09.25.23 Response to Request for Information in connection with The Invitation to Bid Construction Services: ITB No. 08-79-05624, Historical Museum of South Padre Renovation Project.

ADDENDUM NO. 1

PROJECT: Invitation to Bid Construction Services: ITB No. 08-79-05624 Historical Museum of South Padre Renovation Project

5.3

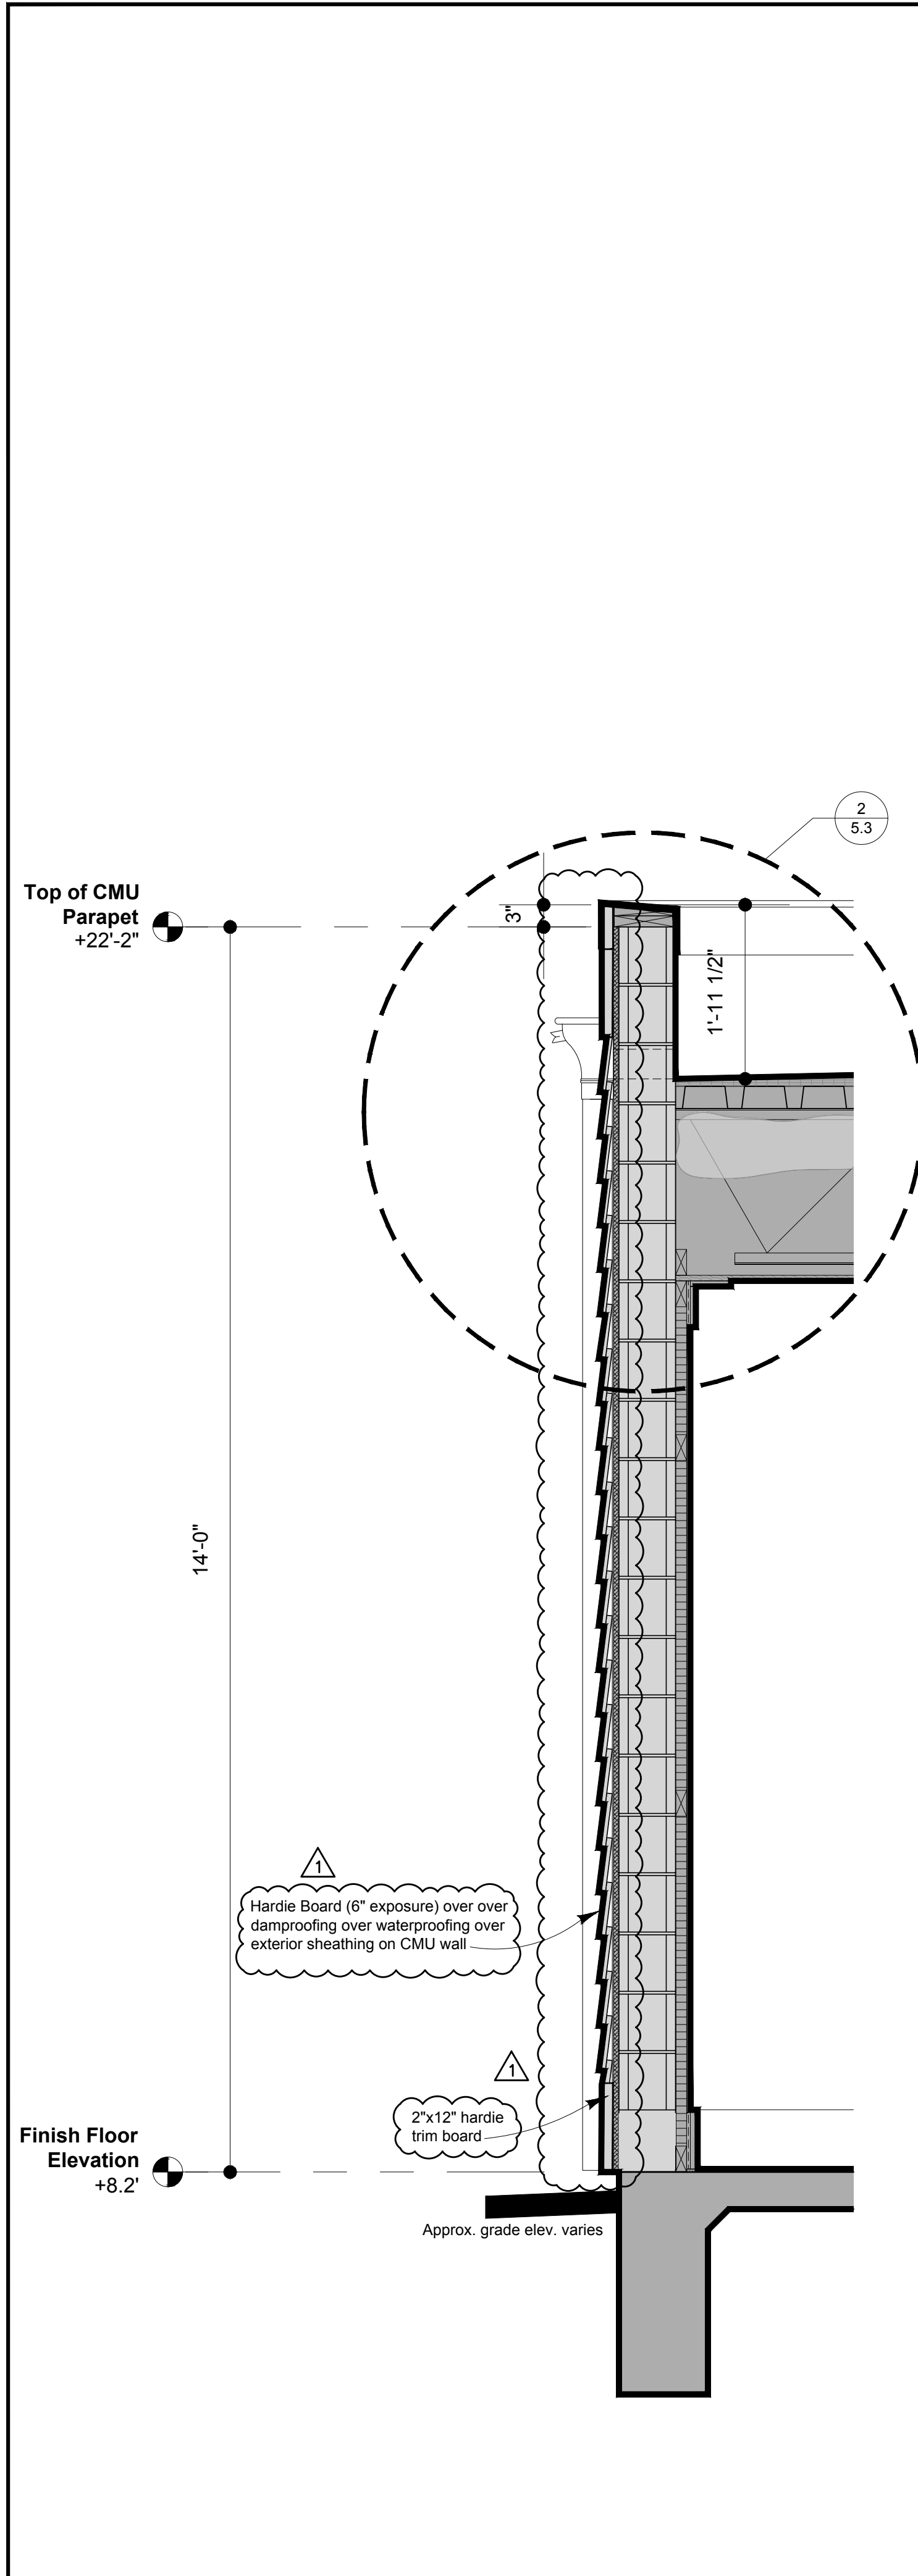
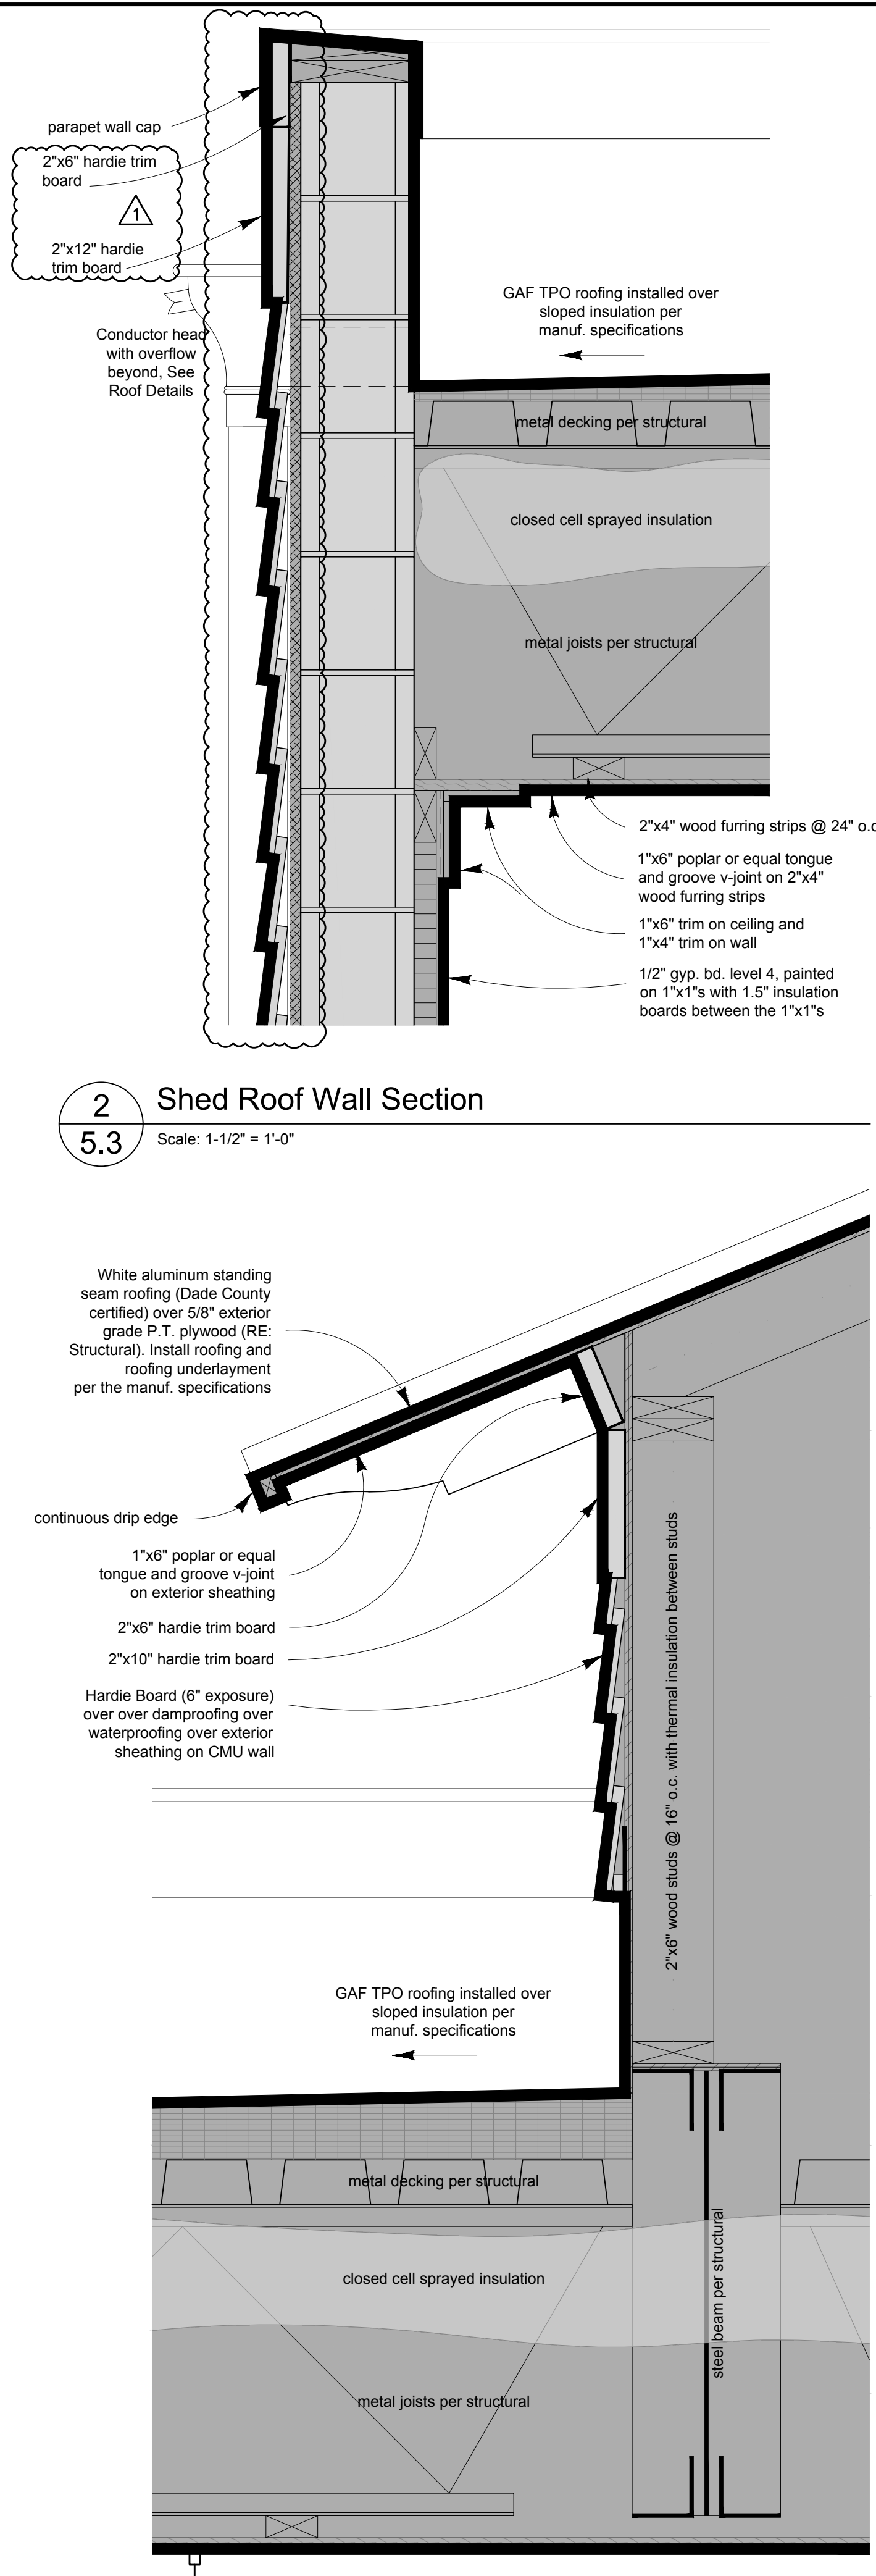
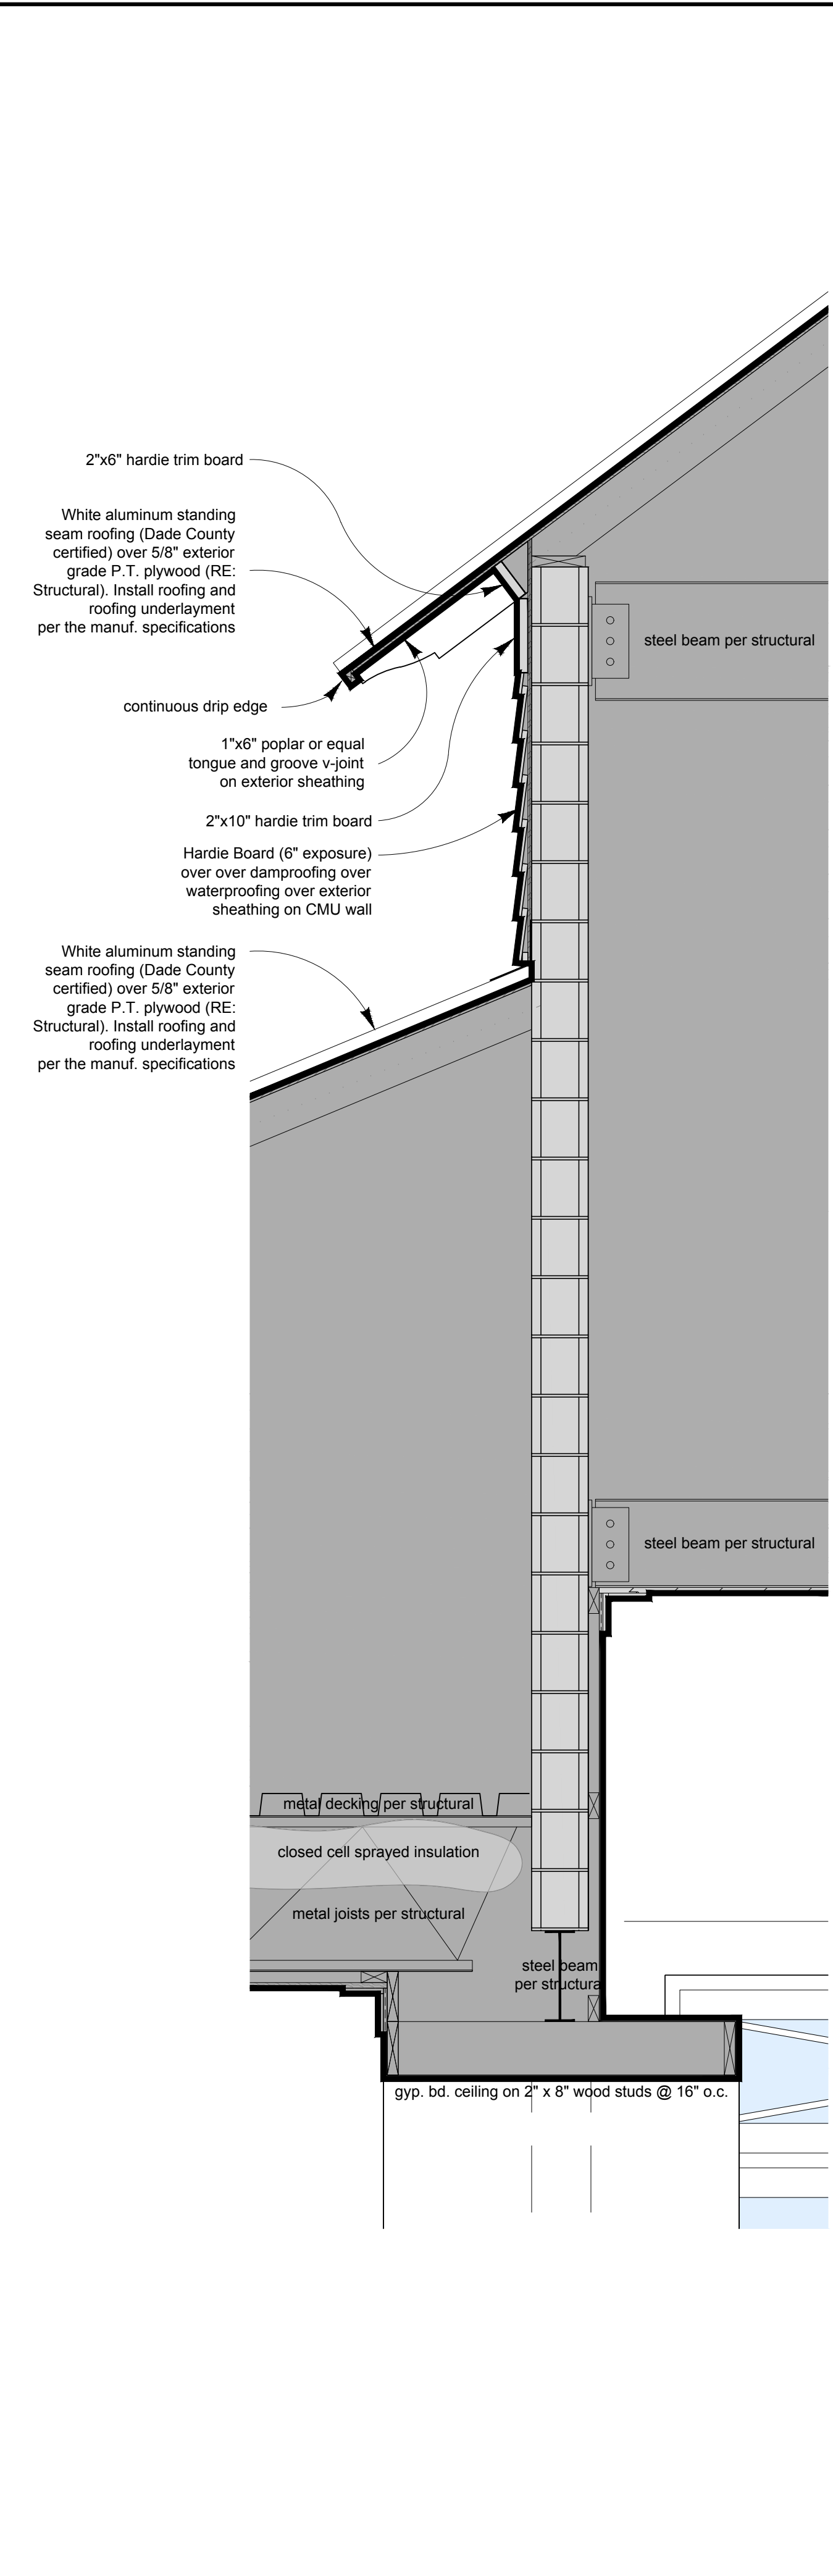
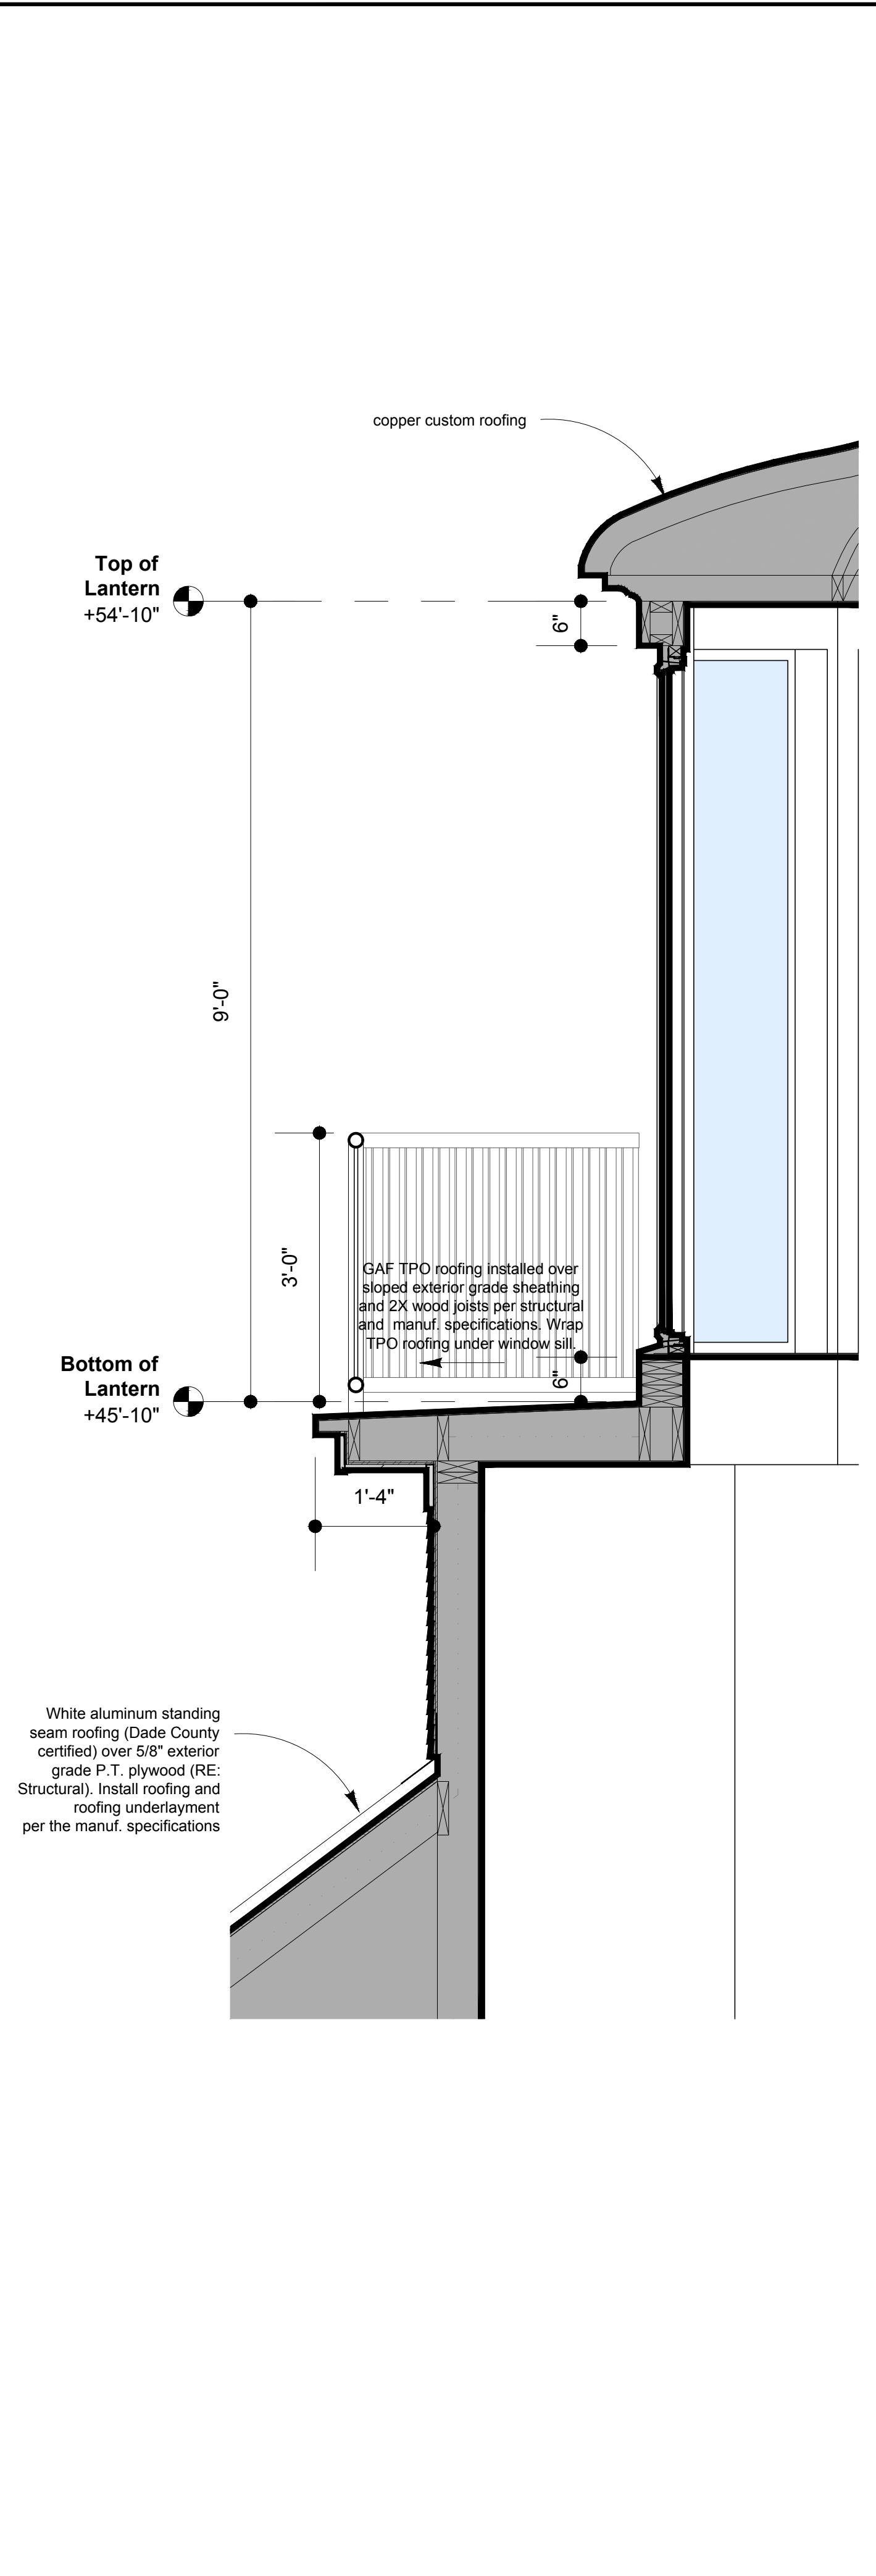
2. Exterior Finishes Clarification:
Ref. to Sheet 4.1 and updated Wall Section and Details Sheet 5.3, dated 09.13.23 attached hereto:
 - a. The majority of the exterior finish shall be Hardie Plank lap-side, smooth finish, with a 6" exposure, as shown on the Elevation Sheets.
 - b. The trim shall be Hardie "Artisan" (1.5"x6") smooth finish at corners, (1.5"x6") smooth around the windows heads and Jambs, and (1.5"x12") smooth at the top of the parapet wall.
 - c. The columns and beam at entry shall be a tropical hardwood, primed and painted.
 - d. The shutters shall be fiberglass from Sea Shutters (850)526-1940.
